Request for Class II Permissive Change(C2PC)

FCC ID: VG8TC934DYY

This is a C2PC application for which the previous grant was issued on 2024-09-23.

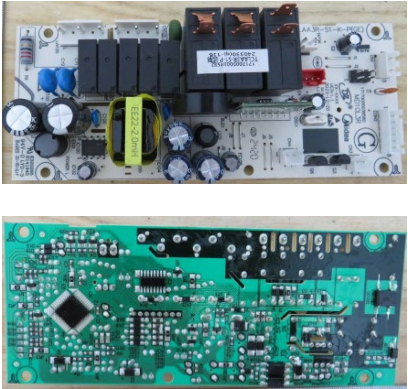
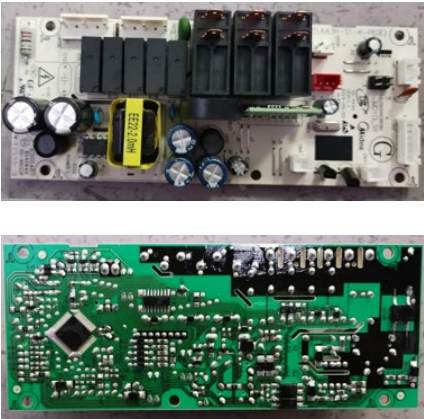
No.	Original	New	Difference(s)
1			Mother board: 1. Remove the Y capacitor on the computer board. 2. The layout of the computer board is changed. 3. The magnetron and other circuit are exactly same as before.
